Title - Sujet New 96 Bed Living Unit - PIRTC	
Solicitation No. - N° de l'invitation EZ899-123081/A	Amendment No. - N° modif. 002
Client Reference No. - N° de référence du client	Date 2012-05-01
GETS Reference No. - N° de référence de SEAG PW-\$PWY-005-6657	
File No. - N° de dossier PWY-1-34503 (005)	CCC No./N° CCC - FMS No./N° VME
Solicitation Closes - L'invitation prend fin at - à 02:00 PM on - le 2012-05-08	Time Zone Fuseau horaire Pacific Daylight Saving Time PDT
F.O.B. - F.A.B. Plant-Usine: <input type="checkbox"/> Destination: <input checked="" type="checkbox"/> Other-Autre: <input type="checkbox"/>	
Address Enquiries to: - Adresser toutes questions à: Pillay, Sal (PWY)	Buyer Id - Id de l'acheteur pwy005
Telephone No. - N° de téléphone (604) 775-9386 ()	FAX No. - N° de FAX (604) 775-6633
Destination - of Goods, Services, and Construction: Destination - des biens, services et construction: CSC - Pacific Institution, Abbotsford, B.C.

Refer to the attached Addendum No. 2 issued 1st May 2012.

SK-1

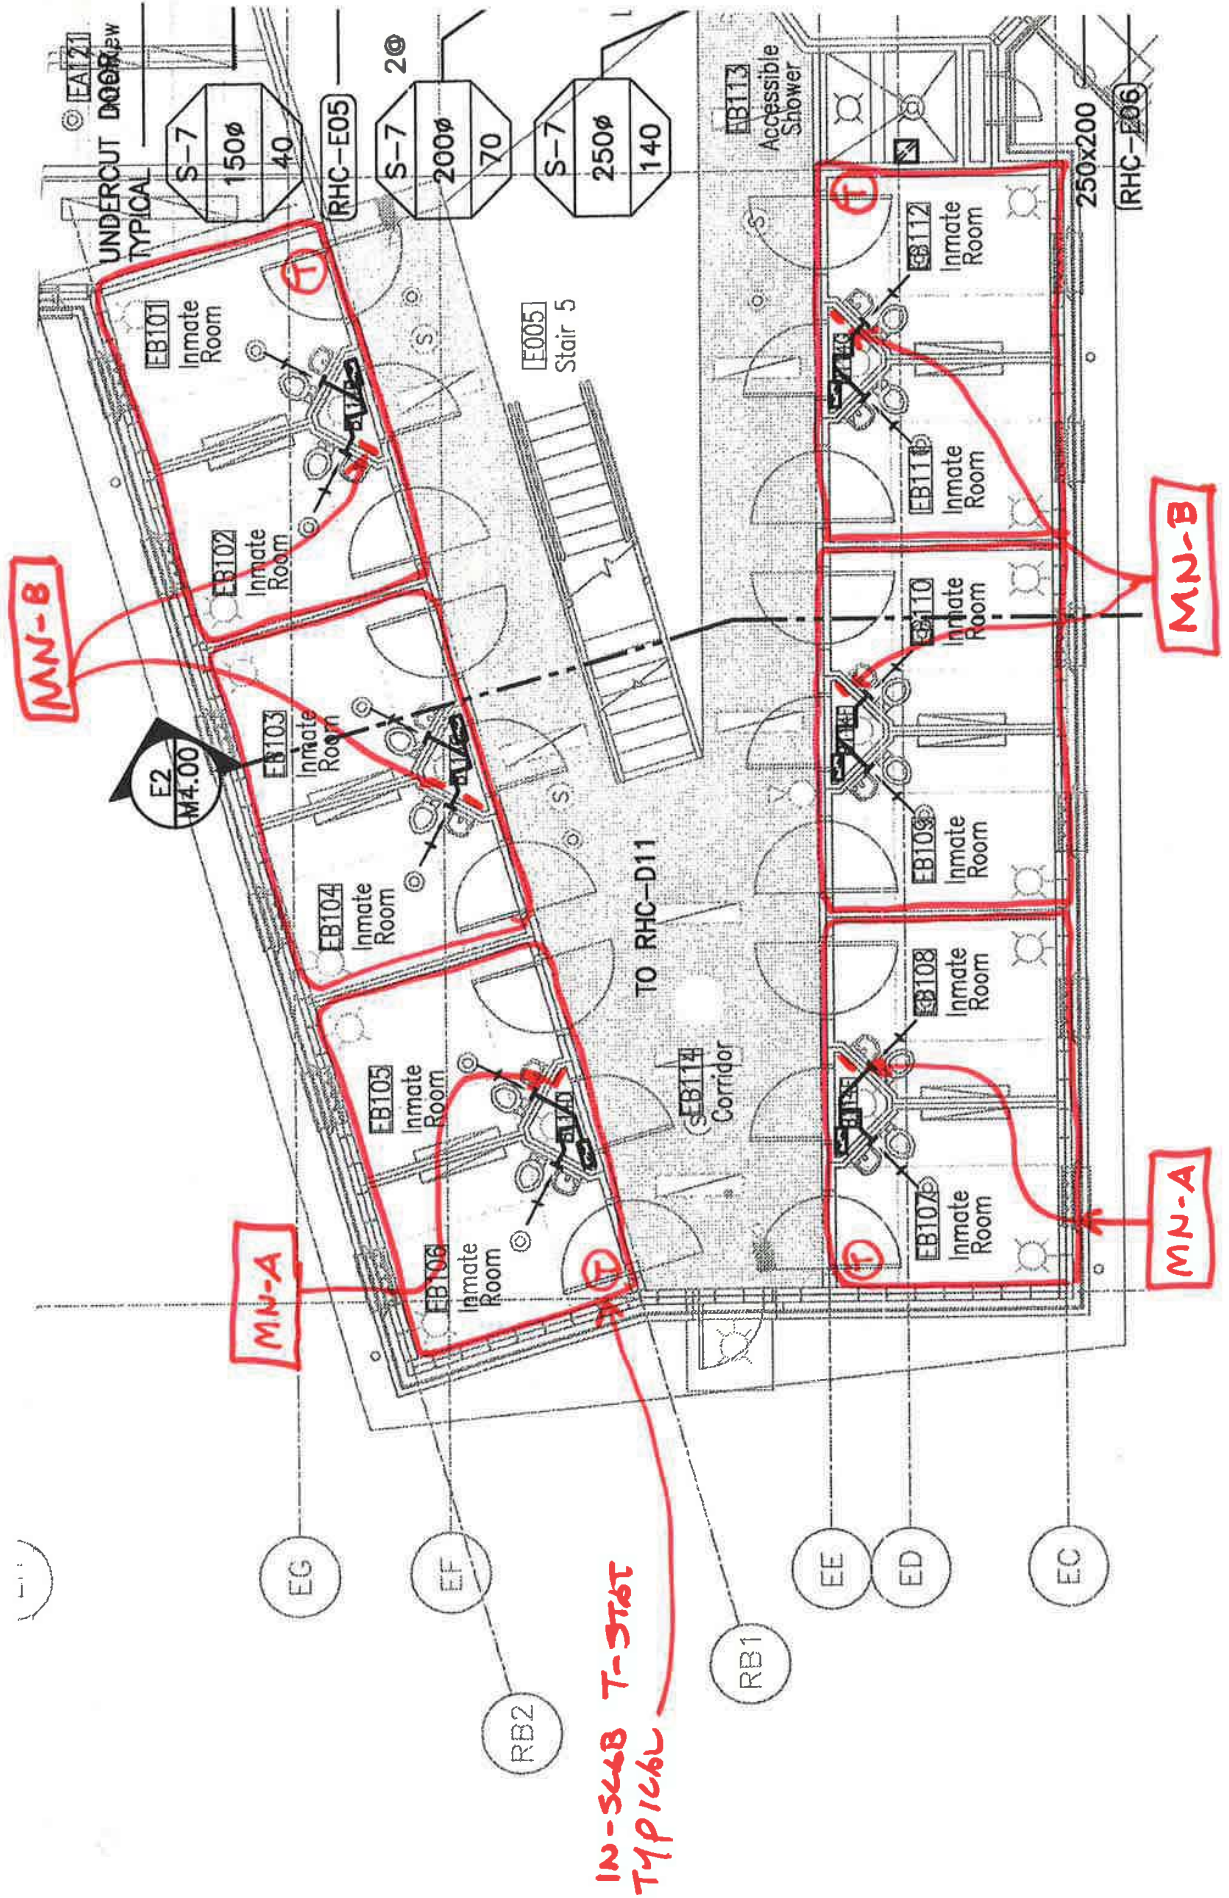
Please provide tag numbers for the Radiant Floor Heating Manifolds and exactly which rooms they serve.

Mechanical Contractor to refer to sketch and schedule attached for typical inmate zones, manifold location, in slab t-stat location and loads as requested.

* TYPICAL MANIFOLD ZONES FOR EXCH RANGE AND BOTH LEVELS
